WINNICHAM & FRADLEY INC.
CONSULTING ENGINEERS SURVEYORS
24" X 36" CLEARANCE
1" @ 12" O.C.E.W. O/E
RECEIVED
☒ APPROVED AS NOTED
DATE 1/3/96
DOCUMENT REVIEWED FOR CONFORMANCE WITH DESIGN CONCEPT. CONTRACTOR SHALL VERIFY ALL FIELD CONDITIONS AND PROVIDE QUANTITIES REQUIRED BY CONSTRUCTION DOCUMENTS.

96-226

FOREGATE
VILLAGE 18

NO.	7
ELEV.	6.10
INV.	(-) 0.75
HT.	6.85
CUT	82"
PRICE	118-118 82"

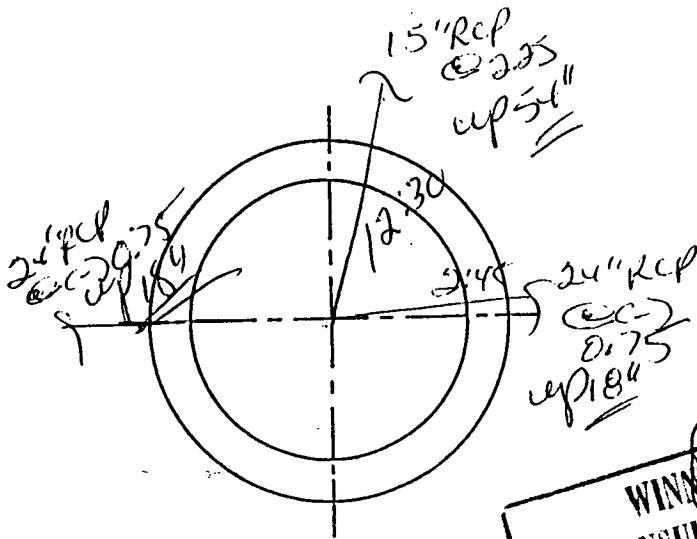
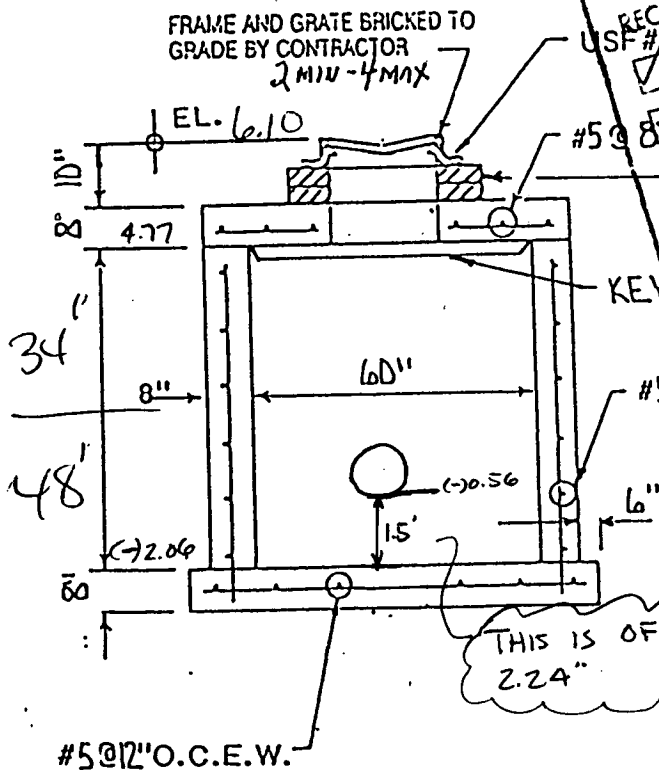
THIS IS OFF BY
2.24"
